UNITED STATES PATENT AND TRADEMARK OFFICE

| 10/585,047 | 06/29/2006 | Hans-Joachim Lutz | 3780 | 6208 |

| Office Action Summary | Application No. 10/585,047 | Applicant(s) LUTZ ET AL. |

DETAILED ACTION

sketch from Fig. 2

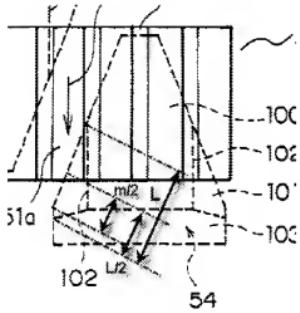
As for claim 1, Asao teaches (in Figs. 1, 5-7, 9 and 13) a claw-pole rotor for an electrical machine, in particular a rotary current generator, [0003] having two pole wheels (51, 52), which each carry claw poles (53 and 54, respectively), which each originate in a plate region (left front plate in Figs. 6 and 7) and have a pole root (103), and on a circumference of the claw-pole rotor (circumference along 103 and 100 boundary), claw poles (53, 54) of the pole wheels (51, 52) are located in alternation, and located between the claw poles or interstices (between numeric 53B and 100 in Fig. 6), and a claw pole (53, 54) has a radially outward-oriented cylindrical-jacketlike surface (100), by which a pivot axis (axis of 6) is defined, and a chamfer (101 or 105) extends on the one hand in a circumferential direction and on the other in an edge direction of a claw pole (53 and 54, respectively), characterized in that the chamfer (101 or 105) has a center portion m in the edge direction that intersects a transition plane (103 and 100 border plane) which demarcates the pole root (103) and the freely projecting part of the claw pole (100),

and the center portion m amounts to 8/10 of the length, oriented in the edge direction, of the chamfer (101); (see sketch below)
and that the claw pole (53, 54) has a width Bk oriented in the circumferential direction, and a half width Bk on the cylindrical surface (100), in a plane of the claw pole (53, 54)

that is vertical to the pivot axis (axis of 6), defines a point (P), and a tangent (T) can be inscribed into this point (P), (see sketch below)

and an angle of inclination α which has a magnitude of between 15° and 25° is enclosed between the tangent (T) and the chamfer (101) in the plane that is vertical to the said pivot axis. (see sketch below)

sketch from Fig. 7 (alpha is 22 degrees)

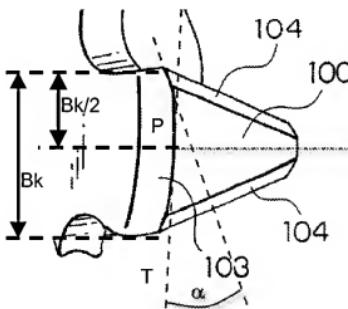
As for claim 3, Asao teaches the claimed invention as applied to claim 1 above. Asao further teaches (in Fig. 2) the chamfer (101) has a center (m) in the edge direction (see sketch above) that is located close to the transition plane (103 and 100 border plane) from the pole root (103) to the freely projecting part of the claw pole (100).

FIG. 3

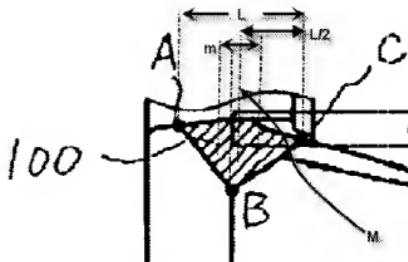
Asao further teaches (in Figs. 1-3) the chamfer (101) is a plane which is oriented parallel to the pivot axis direction (axis of 6). (see sketch below)
